## PRELIMINARY PLAN FILE NUMBER : 120210240

EASLEYS - 904 SILVER SPRING AVENUE

RE: Preliminary Plan No. 120210240  
Easleys  
Preliminary Plan Letter

**Department of Permitting Services  
Fire Department Access and Water Supply Comments**

1 SITE PLAN

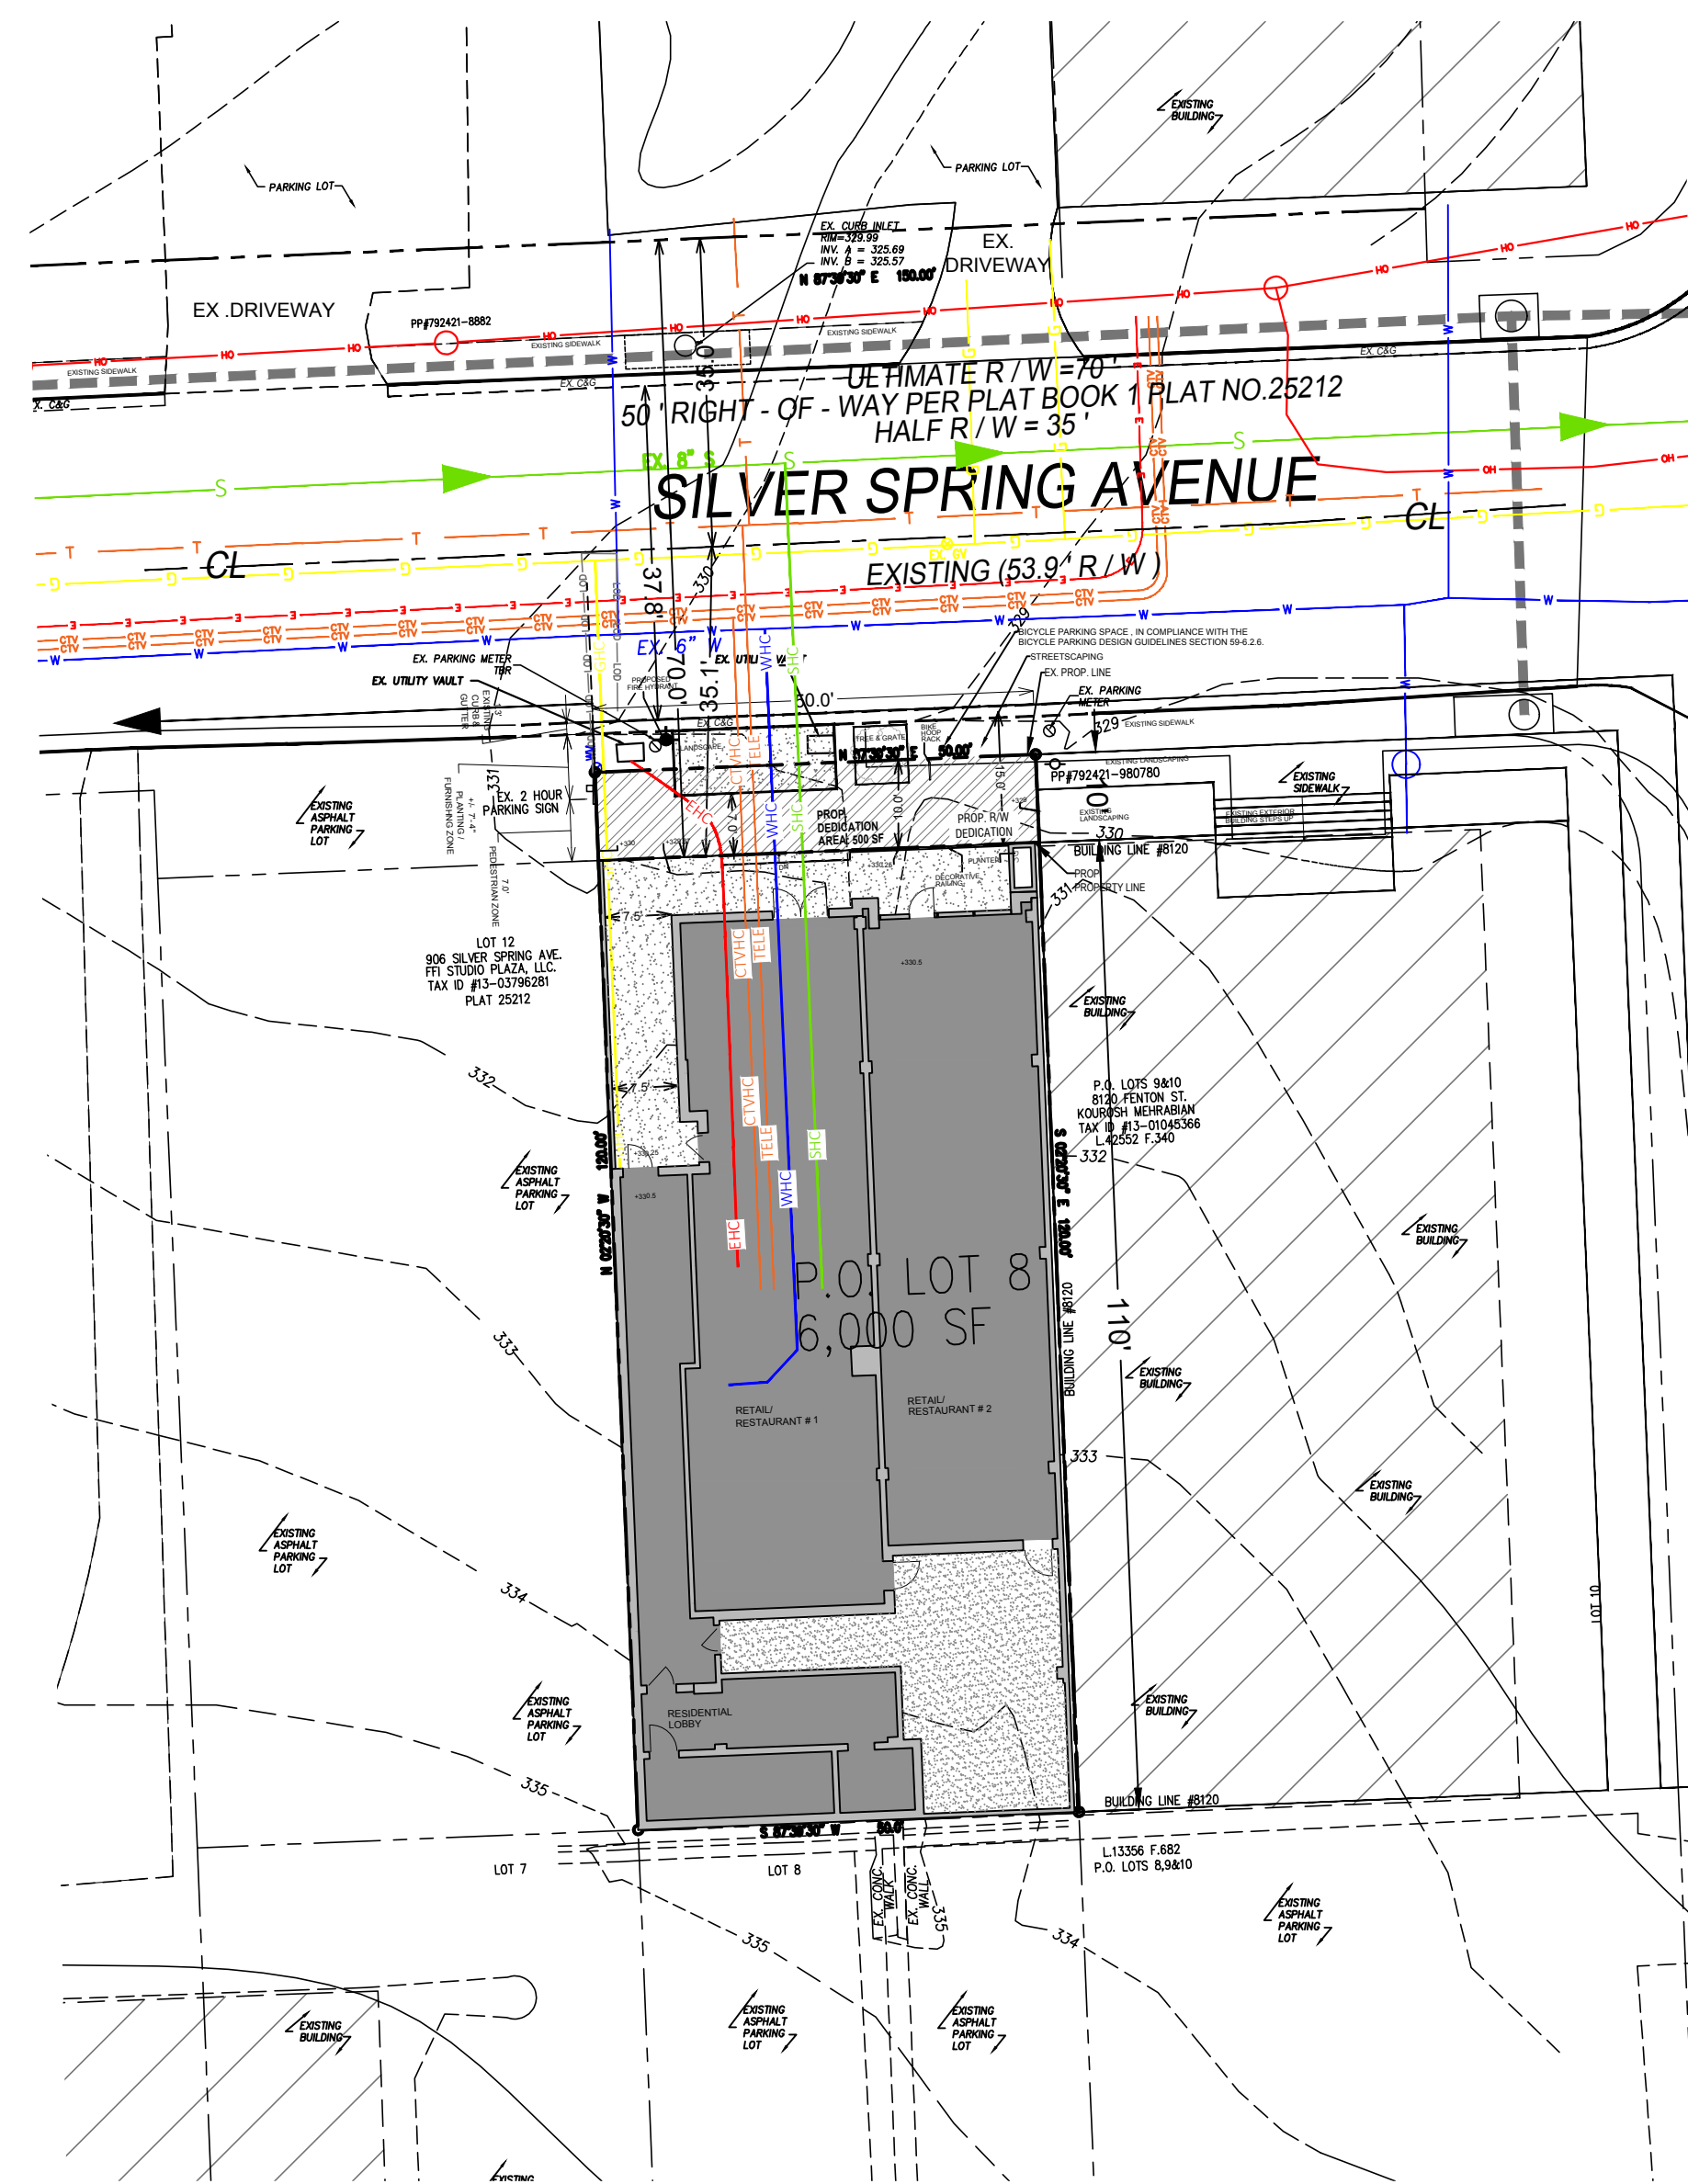
1. The roadway cross section for the roadways along the frontage shall be the following:  
Silver Spring Avenue-From the Property Line to the Face of Curb
  - Proposed 7-ft sidewalk
  - Proposed 7-ft 4-in (7'-4") proposed Planting/Furnishing Zone per Silver Spring Streetscape Guidelines as shown in the plan.
2. **Storm Drain Analysis:** The revised storm drain analysis received via email on May 31, 2022, was reviewed and is acceptable. The applicant shall upload the revised storm drain study to eplans at the certified preliminary plan stage. No improvements are needed to the downstream public storm drain system for this plan.
3. **Sight Distance:** There is no vehicular access to this site, therefore sight distance requirement is not necessary.
4. The streetscape shall be per Silver Spring Streetscape standards.

1. Ensure/ provide/ label ADA compliant public sidewalk along the site frontage and where connections are made to the existing sidewalks.

# FIRE ACCESS PLAN

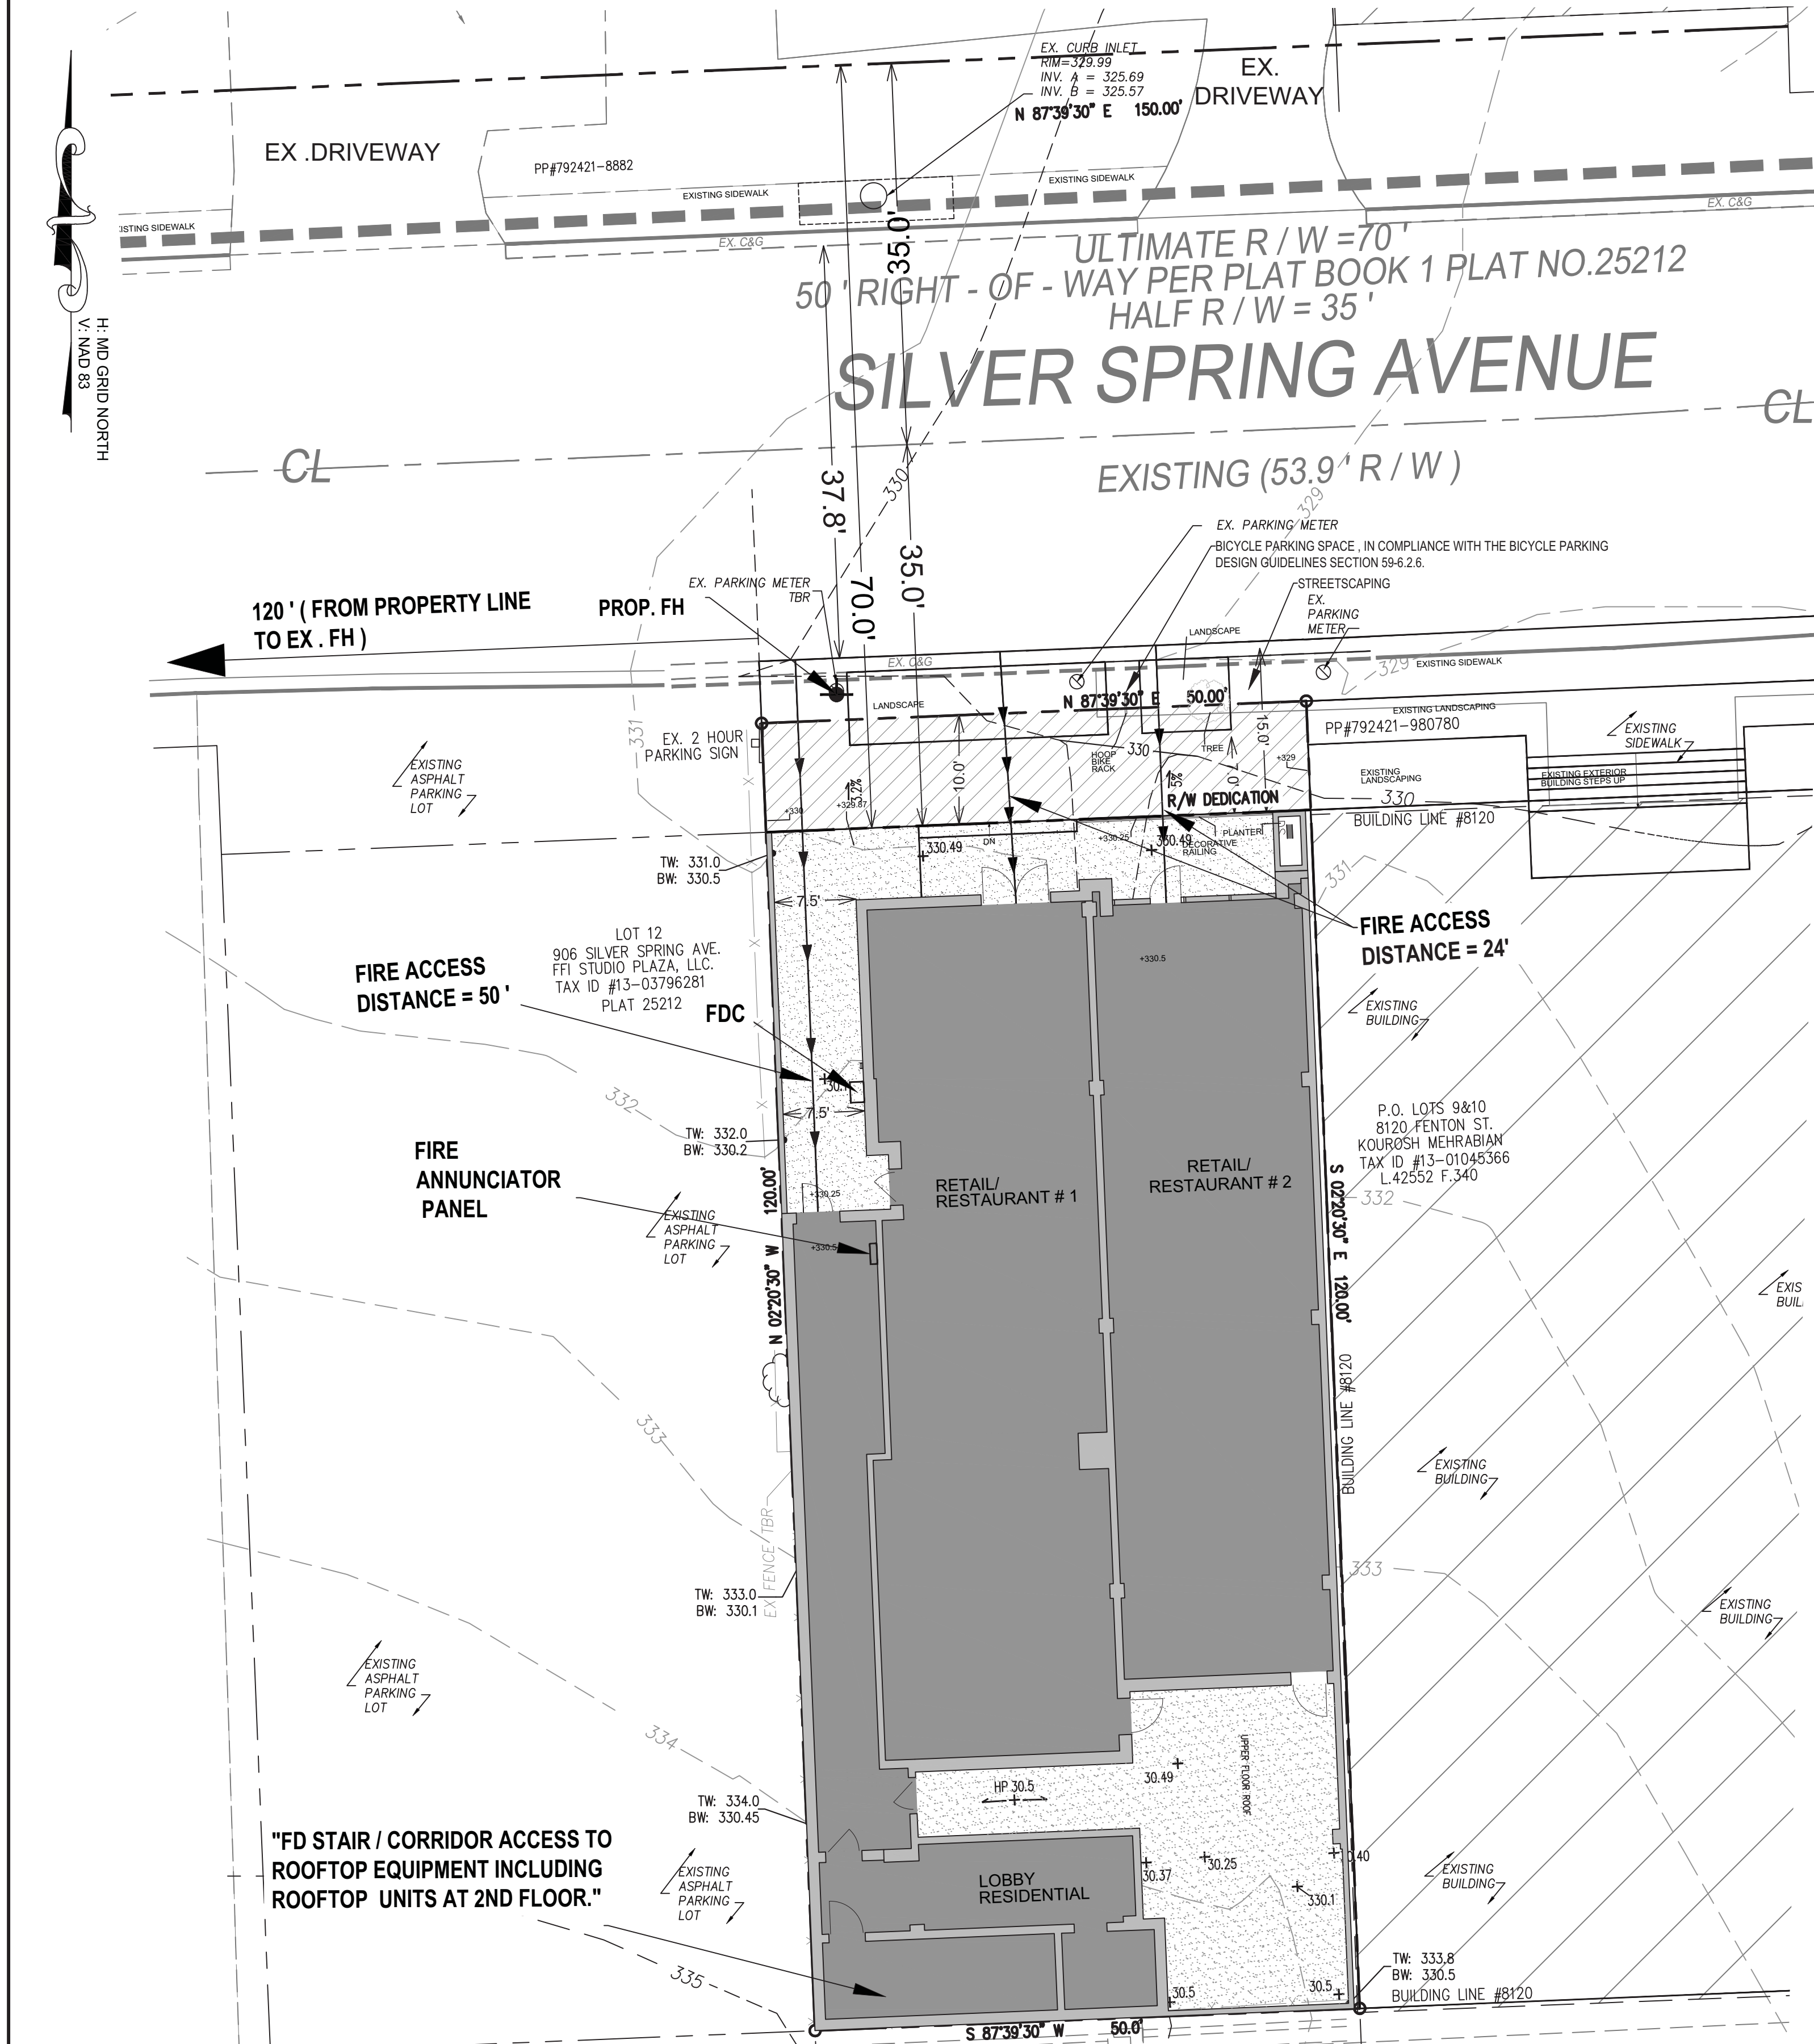
**\*\*\* Building shall meet all IBC and NFPA code requirements to be reviewed and approved by DPS Commercial Building review group including firefighter access to HVAC units which are currently inaccessible from the exterior \*\*\***

As previously discussed, and in consideration of the above reference retail / residential project and on behalf of our client, we are requesting the review and approval of a performance-based design chapter 3, in lieu of the prescriptive compliance with MCER-8-16 section 18.2.3.2.3.6

The MCER- 8-16 requires a 15 feet wide clear and unobstructed walkable grade from a fire department apparatus access point to all around the footprint of a building within 450 feet.

The apartment windows, balconies and roof terraces are oriented towards Silver Spring Avenue. The building west wall is a blank wall, adjacent to the existing building with no window openings. There are no window openings at the rear of the building (South side) and no access for the firefighters to access via ladders or aerial apparatus. The retail spaces have direct frontage to the main street and convenience access to trash/recycling area which loops back to the exit lobby corridor. The FDC and lock box are also located within the fire department access path adjacent to the main residential entrance. The building will be protected with an automatic sprinkler system in accordance to NFPA 13 and a fire alarm system with the annunciator panel located inside the main entrance to the building. We are proposing a fire hydrant to be located in the ROW and within 100 feet from the proposed FDC location.

**PLAN APPROVED**
